**Work Order ID 119587**

Item Name: Crosstube Turning Detail

<b>DART AEROSPACE LTD</b>	<b>Work Order:</b>	119587
<b>Description:</b> Crosstube Assembly (205/212/412 High Fwd)	<b>Part Number:</b>	D212-664-141
<b>Inspection Dwg:</b> D212-664-141 <b>Rev:</b> D		Page 1 of 2

DRAWING NO. D212-664-141	TITLE XTUBE ASSY (205/212/412 HI FWD)	REV. D	DART AEROSPACE LTD ENGINEERING ORDER		D.E.O. NO. D212-664-141-D-1	SHEET NO. SHEET 1 OF 2	SCALE NTS
DRAWN	CHECKED	UP	MFG. APPR.	APPROVED	DE APPR.		
DATE 11.04.07	DATE 11.07.11		DATE 11.04.12	DATE 11/04/12	DATE 11.04.12

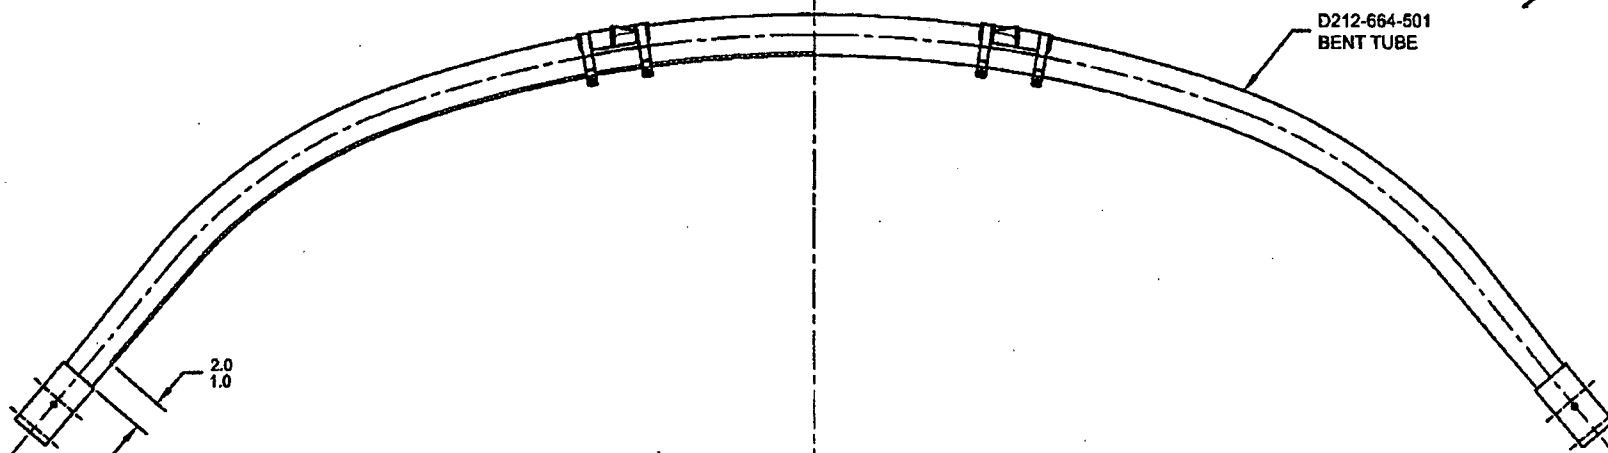
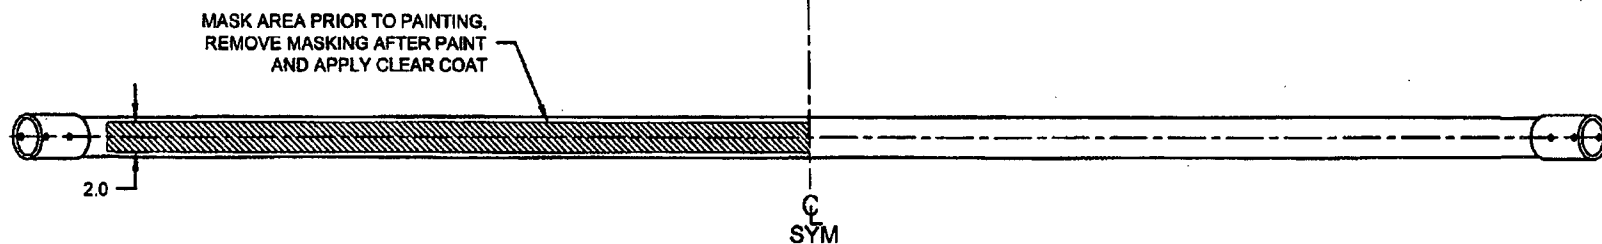
**PURPOSE:**

ADD AN INSPECTION WINDOW TO UNDERSIDE OF CROSSTUBE.

**CHANGE:**

NOTES 2 OF SHEET 1 IS AMENDED AS FOLLOWS:

**IS:**

- 2) FINISH: CHEMICAL CONVERSION COAT PER DART QSI 005 4.1  
PRIME INSIDE AND OUTSIDE PER DART QSI 005 4.2  
MASK UNDERSIDE OF CROSSTUBE AS SHOWN (HATCHED AREA) AND  
PAINT OUTSIDE PER DART QSI 005 4.2  
REMOVE MASKING AND APPLY CLEAR COAT

IS:

WAS:
